**BEFORE AN INDEPENDENT HEARINGS PANEL
OF THE WAIKATO DISTRICT COUNCIL**

IN THE MATTER of the proposed Waikato
District Plan (Stage 1)
Hearing 25

**EVIDENCE OF CAMPBELL JAMES MCGREGOR ON BEHALF OF HYNDS PIPE
SYSTEMS LIMITED AND THE HYNDS FOUNDATION IN OPPOSITION TO
REZONING REQUESTS**

STORMWATER

Figure 4 – Pipeline A Catchments (Source: Plan prepared by Civilplan on behalf of Hynds)

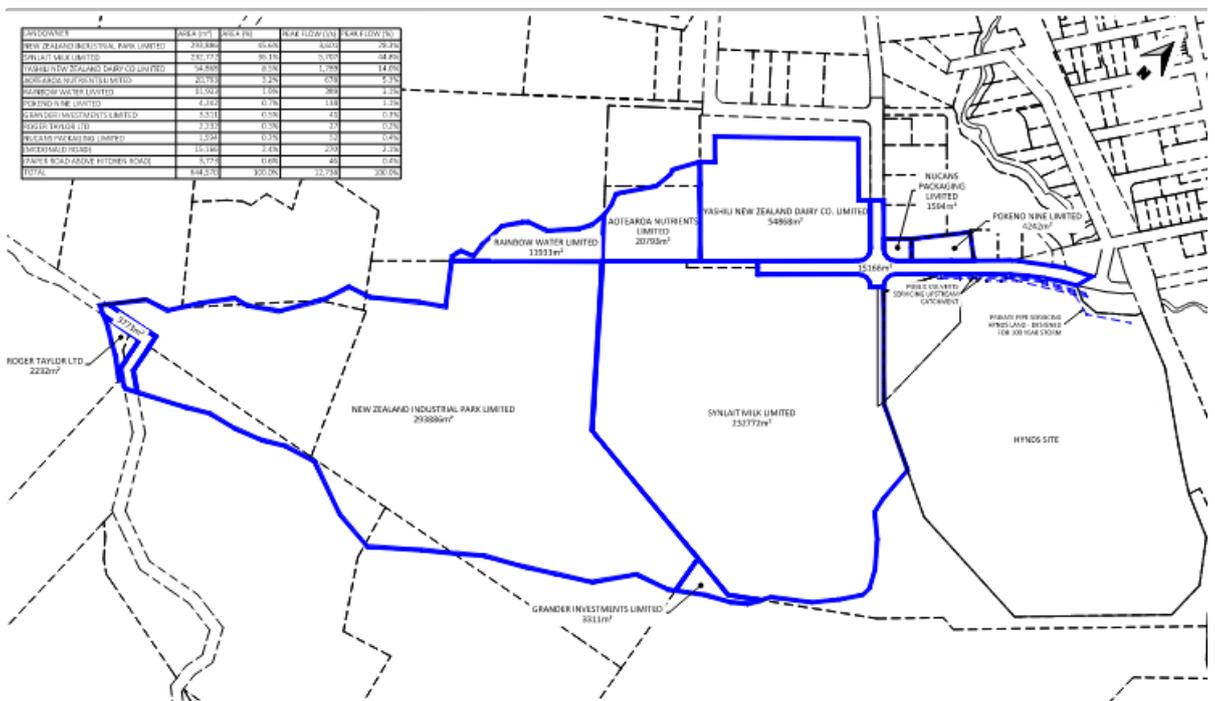
- 3.23** The sizing of Pipeline A assumed catchments remained in their current state as allowed for under the Operative District Plan and that any additional attenuation requirements resulting from each development were met onsite.

- 3.24** I note flow from the land shown in figure 3 as owned by New Zealand Industrial Park Limited (that is now owned by HVL to the west of Synlait), although identified as a contributing catchment in the sizing of Pipeline A, has no direct connection to the pipeline as part of the partially constructed or approved Pipeline A design.

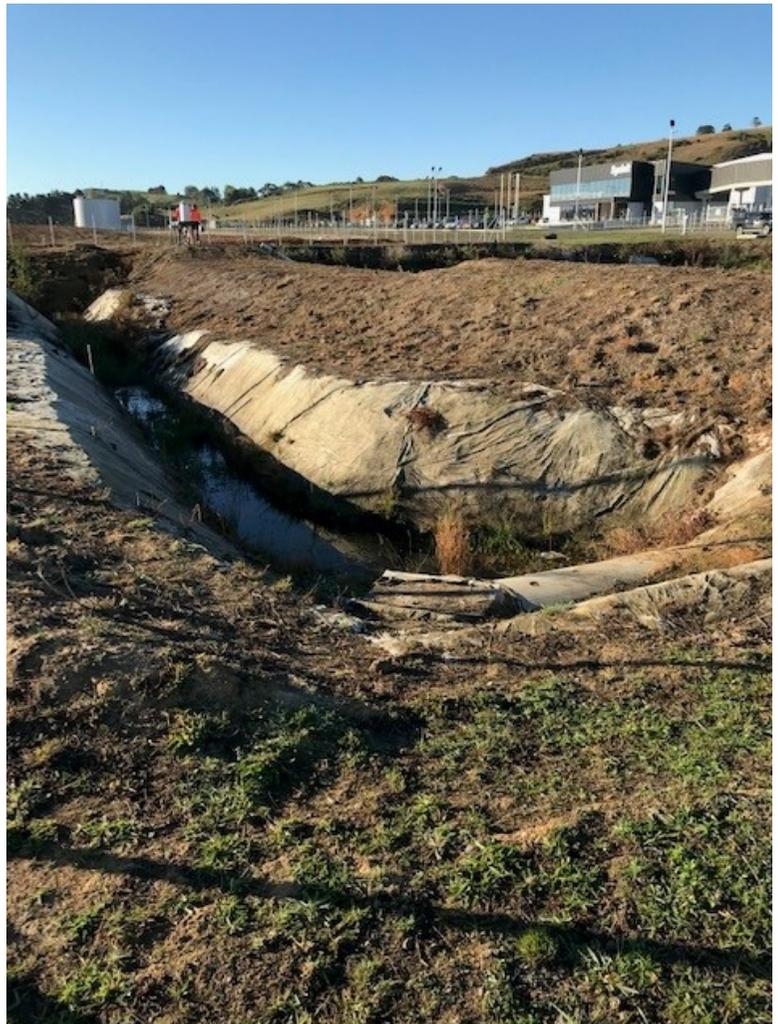
Ditch along Synlait western boundary to headwall

Outlet from pipe on western boundary to ditch in Synlait land along McDonald Road

Inlet under entrance to the Synlait site (end of ditch along McDonald Road west of roundabout)

Temporary outlet from Synlait/HVL rural land which fills ditch and then floods Hynds Land

Figure 6 - Pioneer Road – External Catchment SH1 Stormwater Culverts (62 Bluff Road). Source: Waka Kotahi As built records.

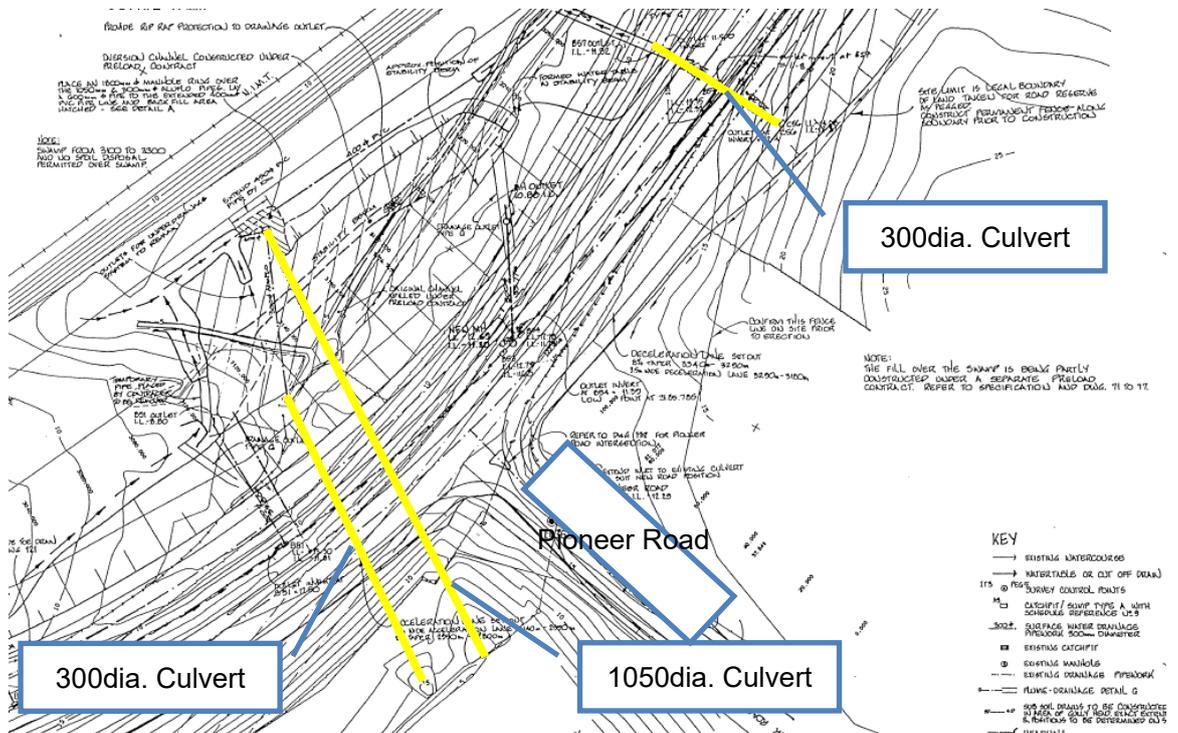
- 4.7** Steven and Teresa Hopkins are seeking Village zoning for their land (label 6). The submitter's land is outside the Tanitewhiora catchment boundary but predominantly falls to a localised gully which is then piped beneath the State

Highway 1 corridor. NZTA records show a 525dia. pipe services this catchment (see figure 7 below). A further 450dia. culvert east of the main gully, services the eastern extent of the land. A small northerly portion of the site (2ha) falls towards Pioneer Road and Bluff Road and will ultimately discharge to the 1200dia. culvert that conveys flows from 62 Bluff Road.

Figure 8: HVL Geology – Source Lander Geotechnical Report, 3rd October 2018

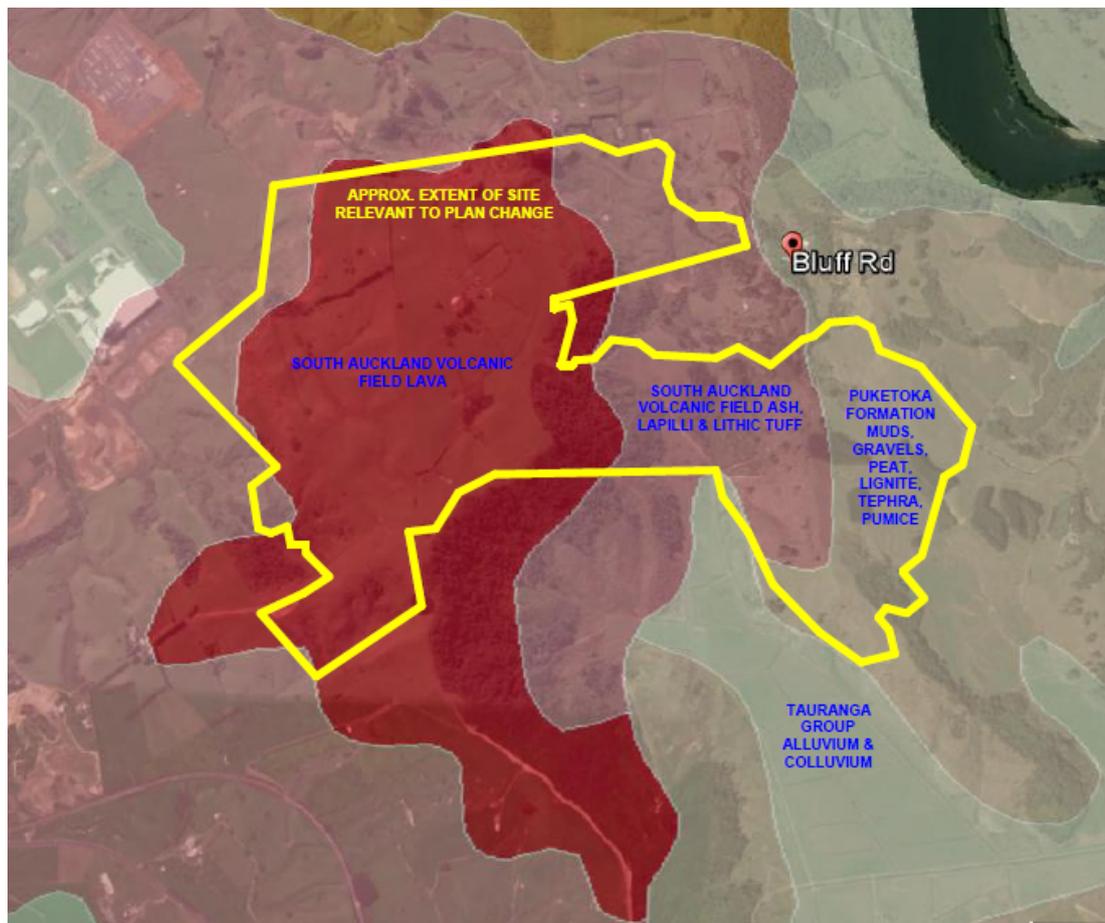
5.6 The soil classifications utilised by Civilplan are for Type C soils which utilise soil Curve Numbers of 70 to 74. Civilplan have stated the curve numbers have been used based on previous experience with similar soils in the area and that this

will be confirmed by geotechnical investigations. Materials specified by the underlying geology maps prepared by Harrison Grierson for the original structure plan (which are also referenced by the Lander Geotechnical report prepared on behalf of HVL) suggest much of the proposed site area is underlain by either Ash, Lapilli and Lithic Tuff or Basalt Rock as part of the South Auckland Volcanic Field.

- 5.7** For these soil types you might typically expect a curve number of 50-60. In relevant terms using the Civilplan specified predevelopment runoff volume for the 10-year predevelopment event (109.7mm), the difference in runoff volume between one hectare of land (time of concentration of 10min) with a curve number of 50 to 74 is 30.6mm to 56.5mm. The runoff from an impervious one-hectare catchment (curve number 98) is 119.2mm. This is significant as this effectively increases the runoff volume difference between the pre- and post-development catchments by approximately 40%.

5.8 While it is likely that a curve number of 50 is perhaps overly conservative given the presence of overlying surficial soil layers, there is still a risk that the attenuation volumes calculated by Civilplan are understated and could therefore require much more significant storage volumes than currently identified. Civilplan suggests site testing will be conducted to confirm the assigned curve numbers, however, given the implications of significantly increasing what are already significant storage requirements (storing up to the 1 in 100-year event), in my opinion this information needs to be obtained now to test the feasibility of the proposed scale of development. This should be done before any change in zoning can be considered.

Figure 9: Stormwater devices proposed by HVL (Civilplan Report)

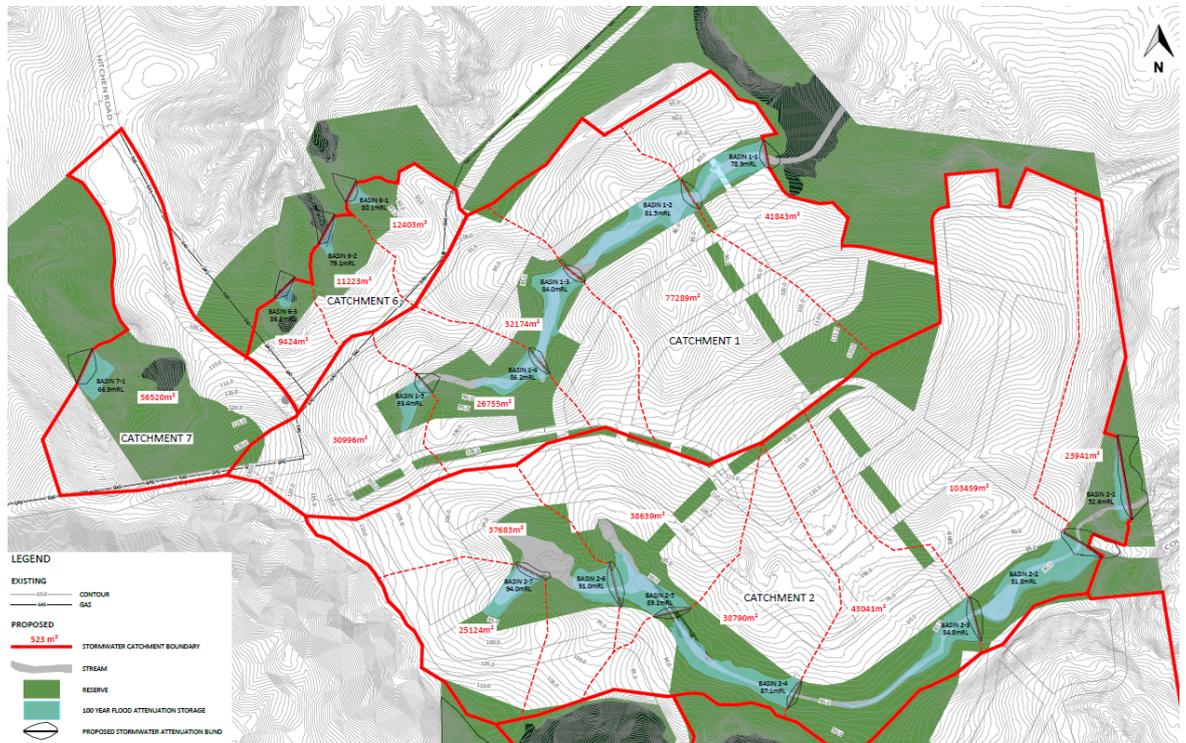
5.17 The second option identified in the Civilplan report (although Mr Pitkethley's evidence suggests this is no longer being pursued) suggests that storage could be provided through a series of terraced basins. For comparison with the above offline storage option, the option suggests the same two catchments (Catchments 1 & 2) would require the formation of 15 basins. To form the basin and required storage area a bund is proposed across the existing stream alignment. The bunds do vary in height, but a review of the provided plans suggests the following:

5.18 The level difference across the water bodies on the stream within catchment 1 is 15m, while catchment 2 is in the order of 40m.

- 5.19** I note that these plans related to the previous version of HVL's masterplan. No updated plans have been provided to indicate how this option could work in the revised masterplan.

- 5.20** While not my specific area of expertise, I consider specialist inputs are required to determine suitable design criteria and safety mitigation to classify the impact on the downstream impact should the bund/dams fail. I believe recent work by the Ministry of Business Innovation and Employment (**MBIE**) has been done in this regard and needs to be considered, including a Potential Impact Classification (**PIC**) of the dams considered.

- 5.23** Accounting for flows should the emergency spillway be required, in my opinion, would also need detailed consideration as there is no flow path which can currently accommodate these flows should the capacity of the system be overcome. As outlined previously there is no direct public road or linkage to the downstream 100-year pipeline (Pipeline A) or McDonald Road to allow for the discharge of overland flows without crossing private property (the Synlait block).

- 5.26** Given the scale of the bunds and ponding proposed, the developed nature of the immediate downstream catchment and lack of a suitably sized flow path to convey emergency flows should the proposed system fail, in my opinion a much more detailed analysis of the proposed Stormwater Management System is required to support the rezoning proposal.
- 5.27** While Mr Pitkethley's evidence suggests (by omission) this option is no longer being pursued, some of the risks associated with bunding/damming and containment of water on what is difficult (steep) topography in my opinion are still relevant for the revised approach discussed in evidence. While these are common stormwater management approaches, the storage of 1 in 100-year flows and absence of identified emergency/secondary flow paths is something that in my opinion needs further definition.
